SCE Fusite® Cover with Improved Cord Relief

Fig.1 117U1028 cover

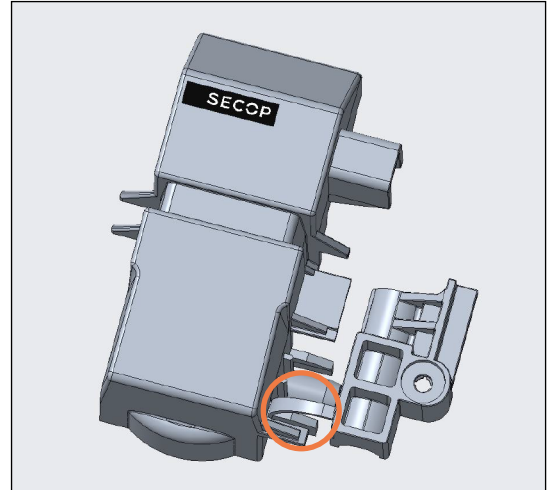
Until now, Secop, has supplied the 117U1028 cover for the SCE21 compressors with a slim cord relief (see Figure 1).

Fig.3 New cord relief design

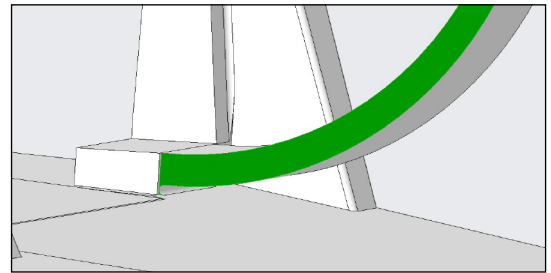
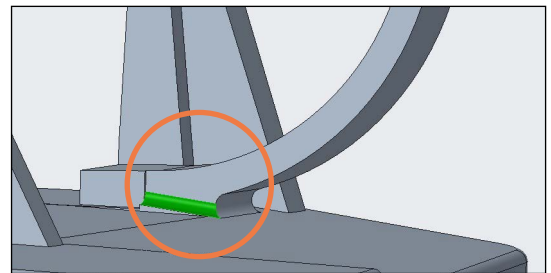
To ensure improved strength and robustness for our customers, Secop has now improved this connection point as illustrated in Figure 2 and Figure 3. Secop modified the radii of the film hinge to minimize the risk of breaking (see Figure 3).
